Developer Services
Southern Water
Sparrowgrove House
Sparrowgrove
Otterbourne
Hampshire
SO21 2SW

Your Ref
AL/64/18/DOC
Our Ref
PLAN-024088
Date
14/08/2018

Proposal: Application for approval of details reserved by conditions imposed under planning permission AL/75/14/OUT relating to condition No.4 (Surface Water Drainage Details), 5 (Sewer Diversion Details), 6 (Cycle parking), 7 (Parking Spaces) & 9 (Construction Management Plan).
Site: Land to rear of Woodgate Farm, Hook Lane, Aldingbourne, PO20 3SS
AL/64/18/DOC

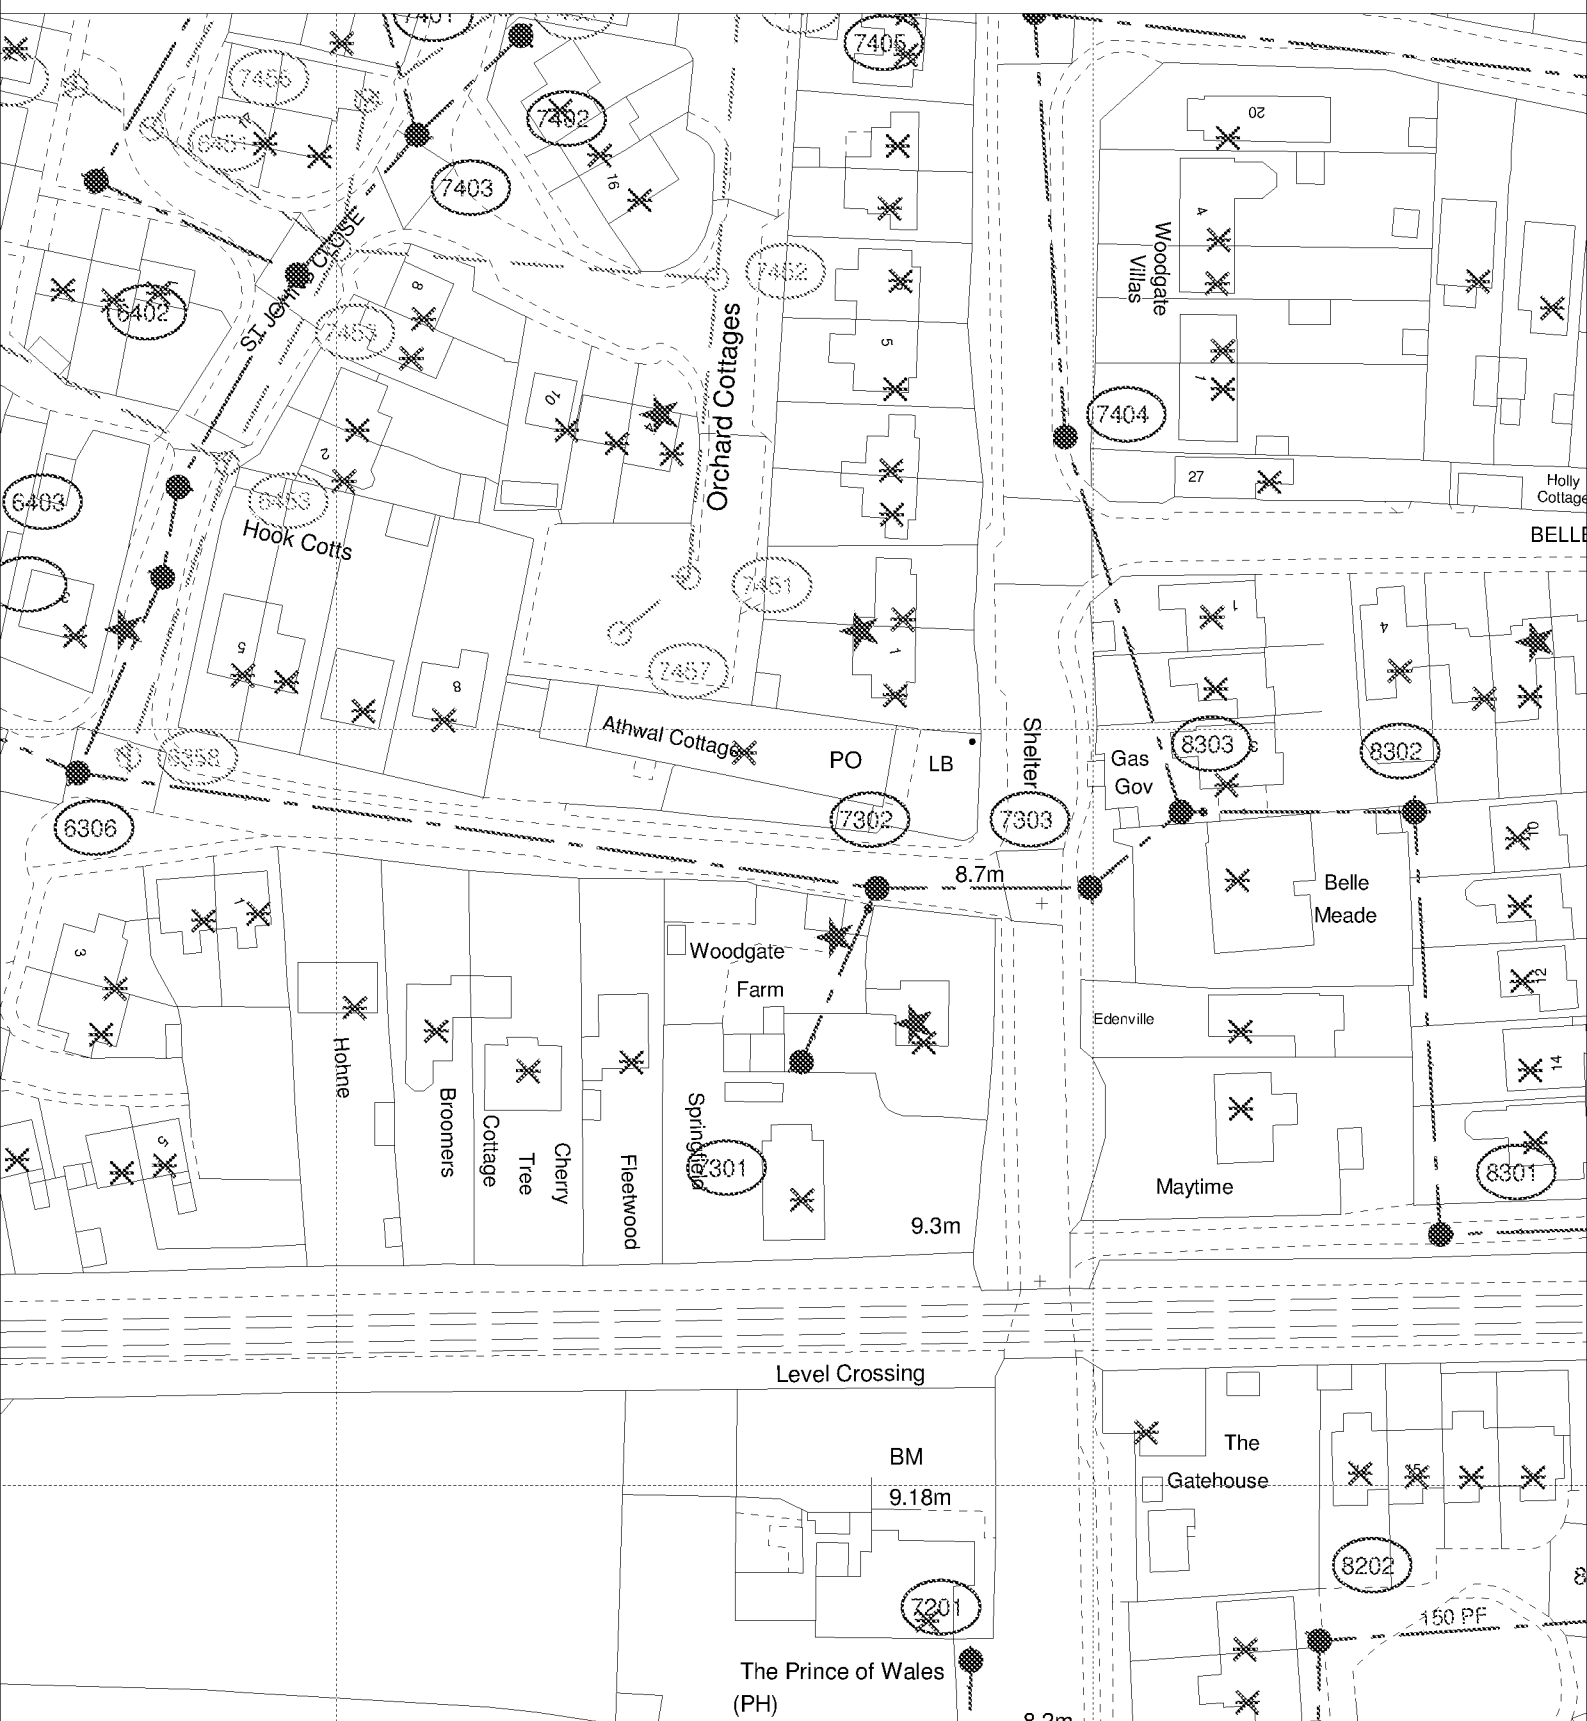
The location of the proposed soakaway results in the on site foul drainage serving the proposed two dwellings not being designed to adoptable standards and Southern Water requirements, so consequently should the drainage be built as shown, Southern Water would not be prepared to enter into an agreement to adopt the sewers or accept them in the future under any change of government legislation. The developer shall source a private maintenance company to maintain and repair the foul sewers within the site boundary.

Southern Water would recommend discharge of condition 5 relating to public sewer diversion. The diversion works shall be carried out strictly in accordance with details approved under Section 185 of the Water Industry Act diversion scheme (our scheme reference SWS.S185.002181).
